## ADDENDUM #1

Reference: Automotive Building Re-Roof  
Dixie State College  
DFCM Project No. 06017640

**AUTO TRADES BUILDING RE-ROOF ADDENDUM #1 ITMES:**

# RF-06

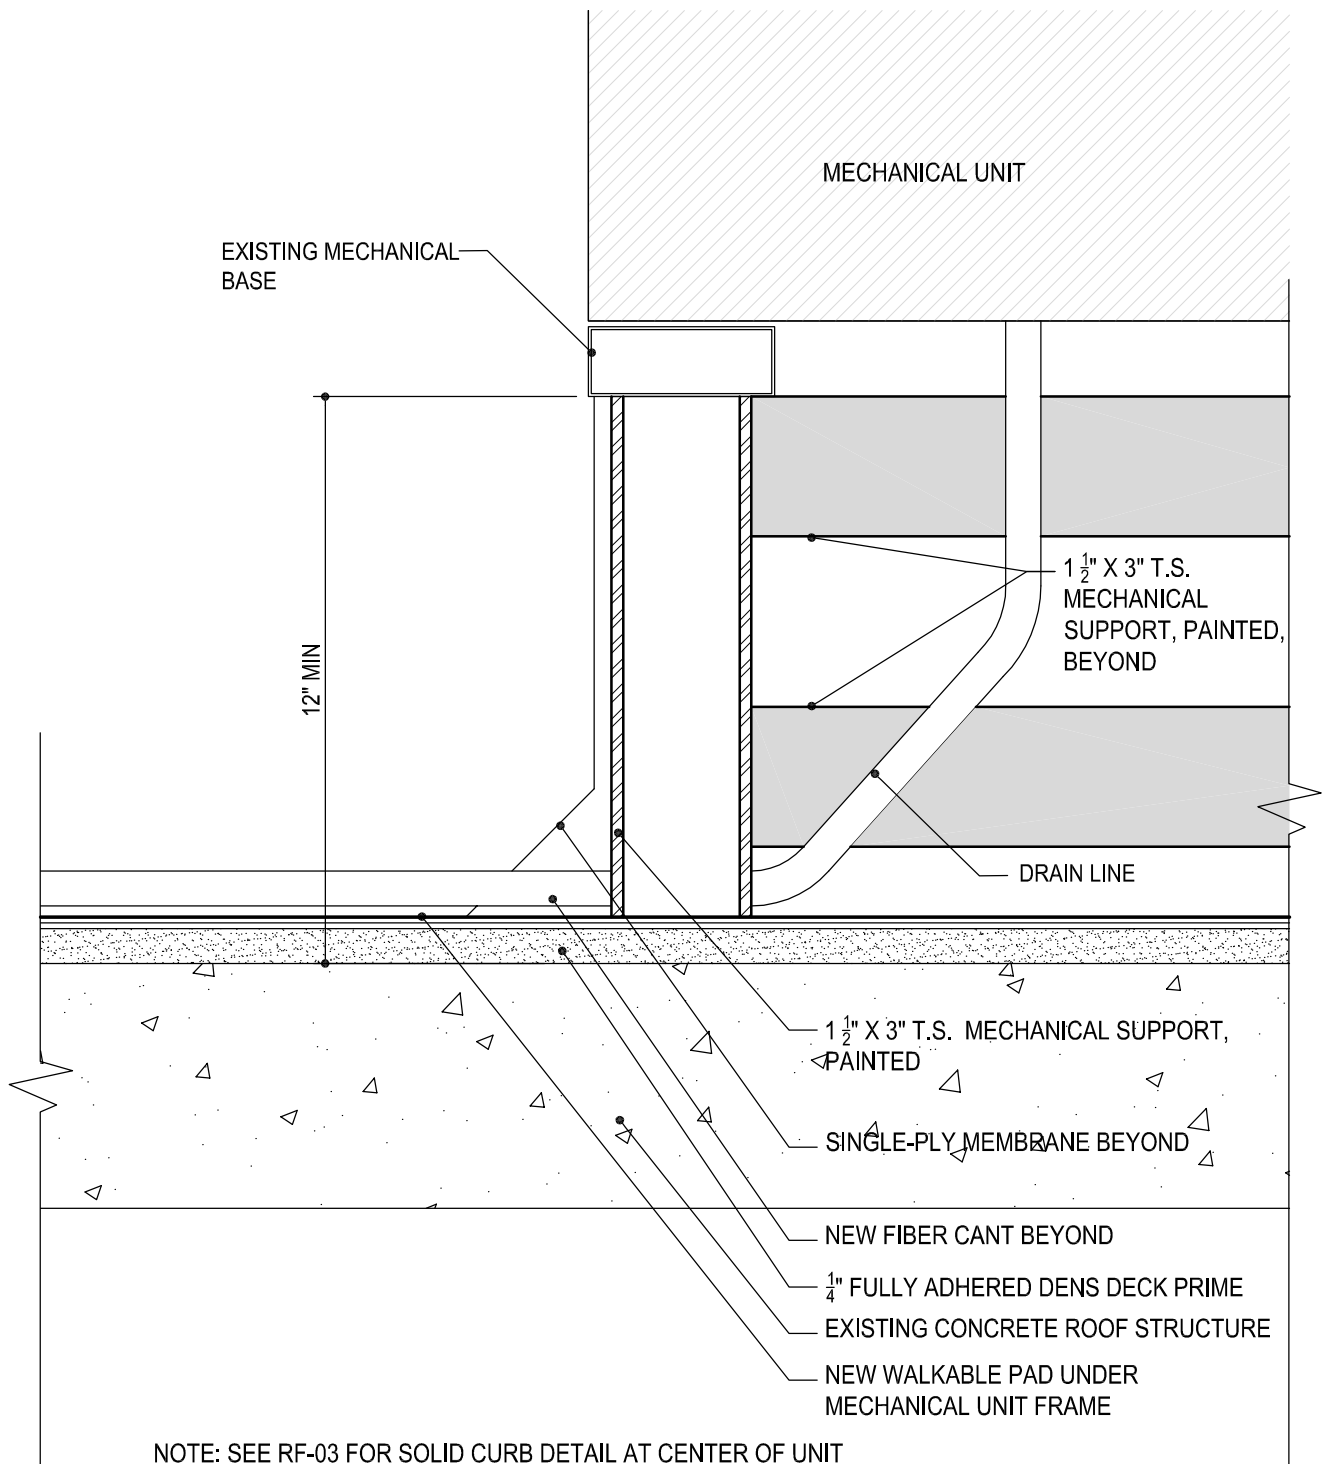
Detail RF-06 Replace parapet cap flashing detail- See attached detail RF-06

NEW PRE-FINISHED METAL FLASHING  
W/ STANDING SEAMS AND CONT. HOLD DOWN  
STRIP.  
REUSE EXISTING WOOD WALL CAP. REPLACE
